# Access Compliance Report

## Public Rights-of-Way

### (Curb Ramps)

Intersection ID: 42957	Main Street: PHEASANT_GLEN_RD	Cross Street: SPARROW_SPRINGS_LN	Location: NE
ADA ID: D7C98E454376	Ramp Type: PerpDiag	Initial Pass/Fail: Pass	Overall Compliance: No
			Severity Score: 10.25

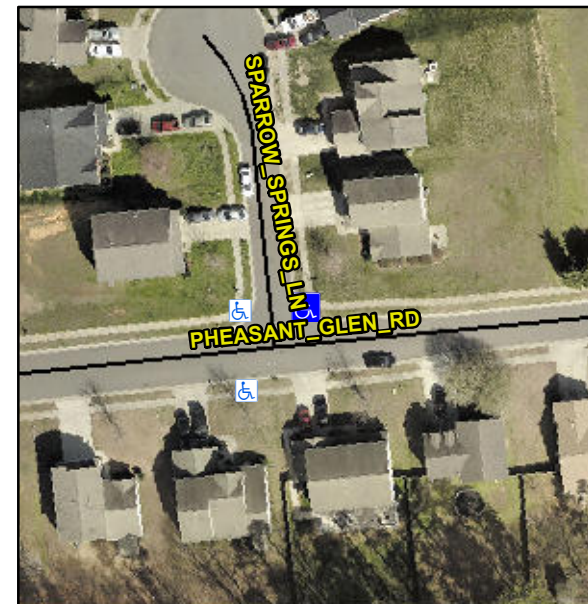
**R304.5.3, R304.2.1, R305**

Compliance	Description	Data	Compliance	Description	Data
N/A	Ramp Length (in)	48.5	Yes	Ramp Slope (%)	6.0
Yes	Ramp Width (in)	48.0	No	Ramp XSlope (%)	2.6
N/A	Flare Type LT	Sloped	N/A	Flare Type RT	N/A
N/A	Flare Slope LT (%)	2.7	Yes	Flare Slope RT (%)	3.8
N/A	Flare Traversable LT?	Yes	N/A	Flare Traversable RT?	Yes
No	Landing Length (in)	45.5	No	DWS Provided?	No
Yes	Landing Width (in)	59.0	N/A	DWS Contrast?	No
Yes	Landing Slope (%)	1.9	N/A	DWS Length (in)	N/A
Yes	Landing X Slope (%)	0.8	N/A	DWS Full Width?	No
N/A	Landing Curb? (Y/N)	No	N/A	DWS Offset (in)	N/A
N/A	Shared Landing?	No			
Yes	Gutter Ponding?	No	Yes	Gutter Slope (%)	0.7
Yes	Gutter Lip Ht (in)	0.0	No	Gutter X Slope (%)	3.1
N/A	Painted X Walk1?	No	N/A	Painted X Walk2?	No
	X Walk 1 Direction	To W		X Walk 2 Direction	To S
N/A	X Walk 1 Width (in)	N/A	N/A	X Walk 2 Width (in)	N/A
	X Walk 1 Slope (%)	3.3		X Walk 2 Slope (%)	3.0
	X Walk 1 X Slope (%)	3.9		X Walk 2 X Slope (%)	3.5

**Remove & Replace Curb Ramp With Two New Directional Ramps or Equivalent. Remove & Replace Gutter.**
